Subject: ParkSmart HVAC Modules

Models Affected: Specific Freightliner Cascadia vehicles manufactured March 25, 2014, through November 9, 2015 and equipped with a certain ParkSmart Auxiliary HVAC system.

June 2016
FL703A
NHTSA #16V-143
Transport Canada #16-113
REVISED NOTICE

ParkSmart Serial Number Inspection and Compressor Cap Installation

Fig. 8, Yellow Discoloration and Melting of the Block Connector

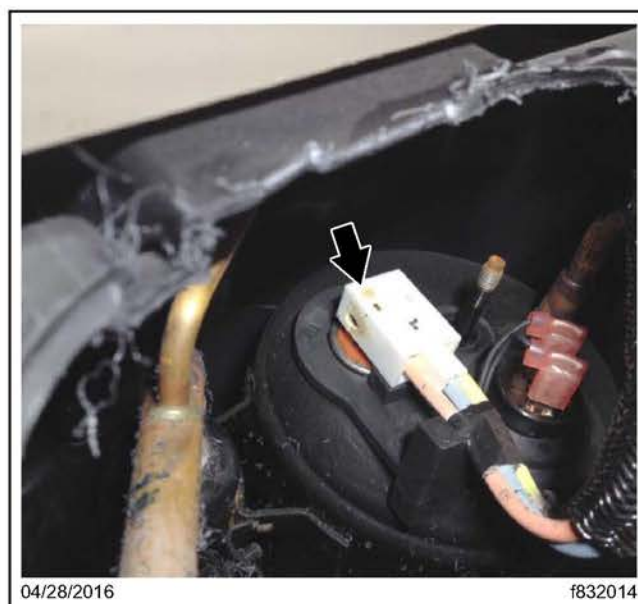
14. Using a mirror as needed, inspect all sides of the block connector for evidence of heat damage such as discoloration and/or melting. See **Fig. 8**.

If the block connector shows evidence of heat damage, go to "Compressor Harness Replacement" on page 12 of these work instructions.

Fig. 9, Aluminum Connector Cap

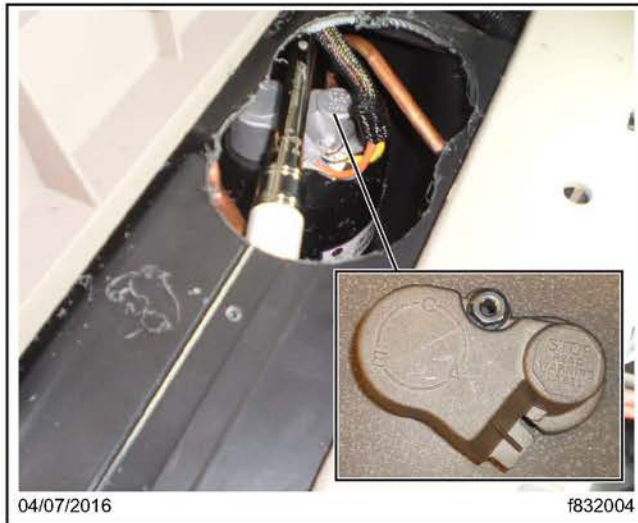
15. Install the new aluminum cap and retaining nut from the kit. Tighten the nut 40 to 45 lbf-in (452 to 508 N-cm). See **Fig. 9**.
16. Install the new compressor access cover from the kit. See **Fig. 10**.

Fig. 10, Installing the Compressor Access Cover

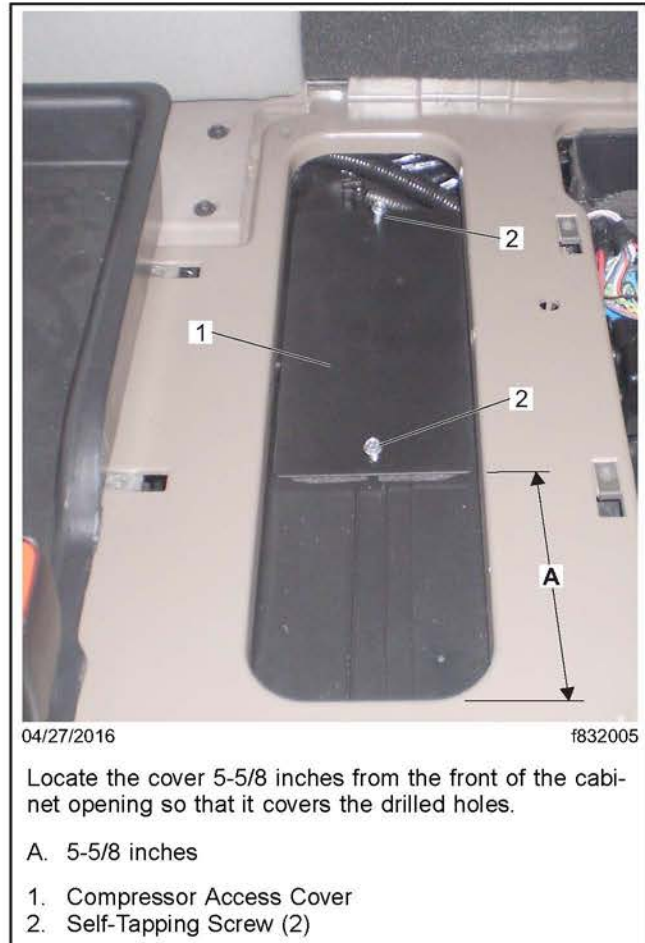
Locate the cover 5-5/8 inches from the front of the cabinet opening so that it covers the drilled holes.

Fig. 13, Circuit Board Wiring

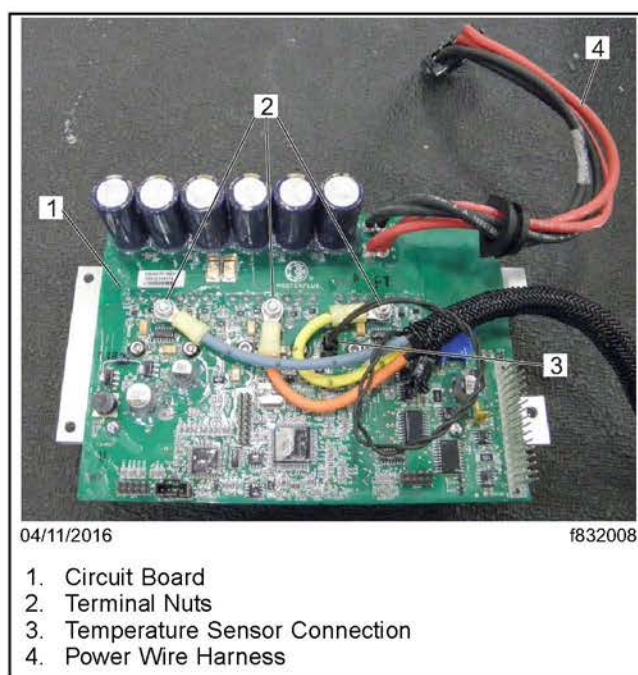
17. Connect the three phase-wires of the new harness to the circuit board terminals as shown in **Fig. 13**. Install the blue wire on the left terminal, the orange wire on the middle terminal, and the yellow wire on the right terminal. Carefully tighten the nuts 10 to 14 lbf-in (113 to 158 N-cm). Do not over tighten or under tighten.
